SS 1034783 20K Detroit Axle King Pin Lube Access

Concern:

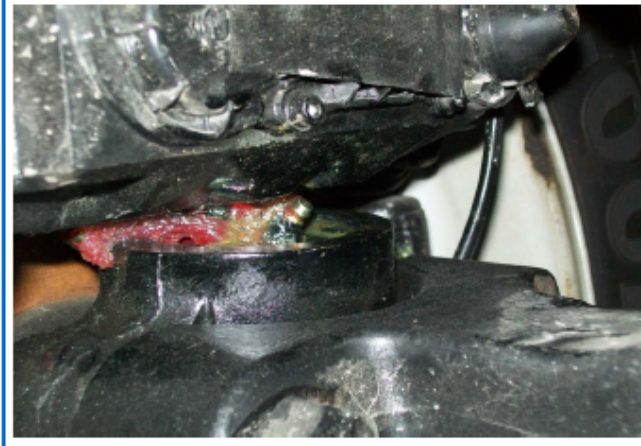
WST trucks equipped with 20k Detroit front axles and disc brakes built up to 8/17/2020 do not have sufficient room to access the king pin grease zerk.(see below)

Retro fit axle for remote grease zerk. See pictures and parts list below.
